GE Hitachi Nuclear Energy

MFN 09-647
October 20, 2009

Subject: Response to NRC RAIs - NEDC-33173P, Supplement 3

Response to NRC RAIs - NEDC-33173P, Supplement 3

Figure 11-1. Illustration of the BSP Controlled Entry Regions and Base Scram Region

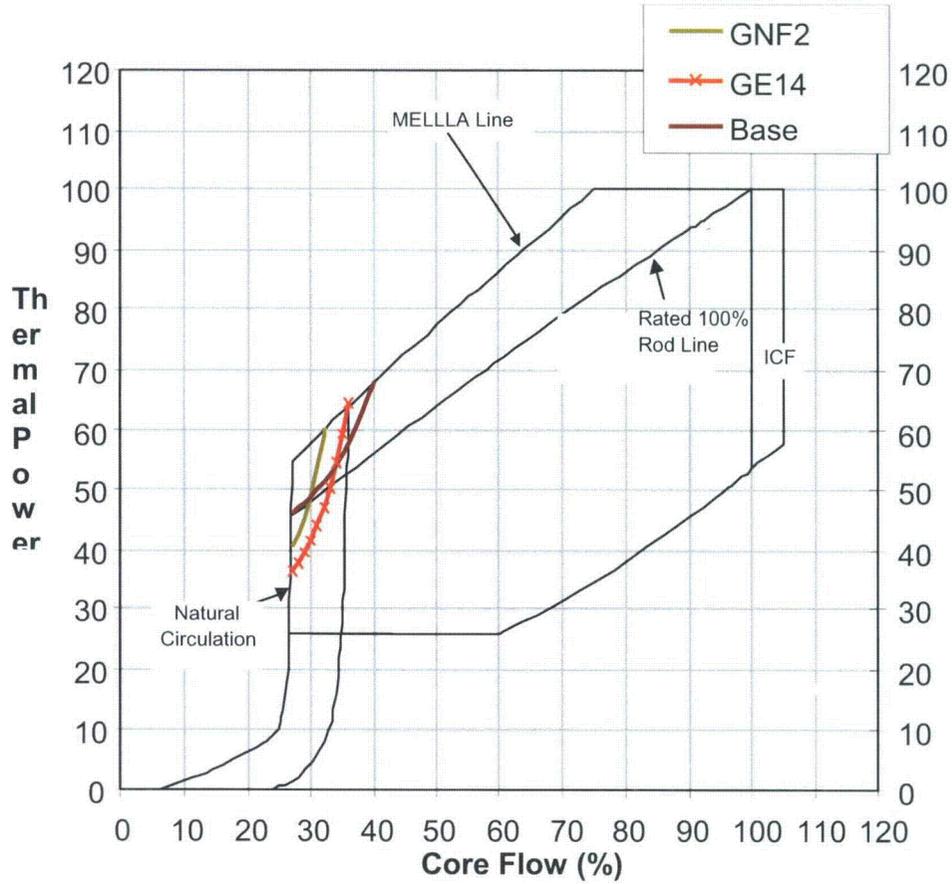
BSP has been approved by the NRC staff for implementation at Option III plants. However, NEDC-33173P, Revision 1 does not explicitly discuss BSP for Option III. Please provide a discussion similar to those in NEDC-33173P, Revision 1 addressing BSP for Option III. It is expected that the nature of this discussion will be generic, but please give specific consideration to GNF2.

The calculation of the BSP region boundary is based on a conservative ODYSY (One-Dimensional Dynamic Code for Stability) acceptance criteria map that may be influenced by the core wide axial power distribution calculation. However, the ODYSY methodology requires the use of a conservative Haling power shape, and this is a limiting flat axial power shape compared to actual power shapes throughout the cycle. Therefore, uncertainties in the actual axial power distribution do not affect the calculation of the BSP region. Also, any uncertainties in either local or radial power distribution have no influence on the core-wide decay ratio (Reference 11-2).

Two new ODYSY cases were generated based on the Amendment 22 (A22) GNF2 and GE14 PANACEA wrap-ups. One case was along the MELLLA boundary (or the High Flow Control Line, HFCL) and the other case was along the Natural Circulation Line (NCL). The power/flow search along the NCL and the power/flow search along the HFCL yielded the 0.80 core decay ratio power/flow state points for both GNF2 and GE14 as requested in this RAI. These two comparisons bound the Modified Shape Function (MSF) or Generic Shape Function (GSF) state points in terms of bypass voiding conditions. Hence no additional MSF or GSF state points are presented here. Figure 11-1 illustrates the Controlled Entry Region boundary corresponding to the 0.80 core decay ratio for both GNF2 and GE14 using the GSF. The GNF2 Controlled Entry Region boundary tends to be smaller compared to that of GE14 as was pointed out by the staff. A smaller Controlled Entry Region boundary is conservative for the bypass voiding application since this penetrates deeper into the less stable region of the power/flow map (top left corner), where bypass voiding is more severe.

Please note that the BSP analysis is used a backup solution for Option III and that the BSP Scram Region boundary cannot be smaller than the Base BSP Scram Region (Reference 11-5), with the boundaries generated by applying either the GSF or MSF to Points A and B:

Point A: Intersection of the MELLLA upper boundary and 40% rated core flow,

Point B: Intersection of the NCL and 100% Original Licensed thermal Power (OLTP) load line.

The Base BSP Scram Region with the GSF option is also illustrated in Figure 11-1. Hence, the size of the Controlled Entry Region is also limited by the Base BSP Scram Region.
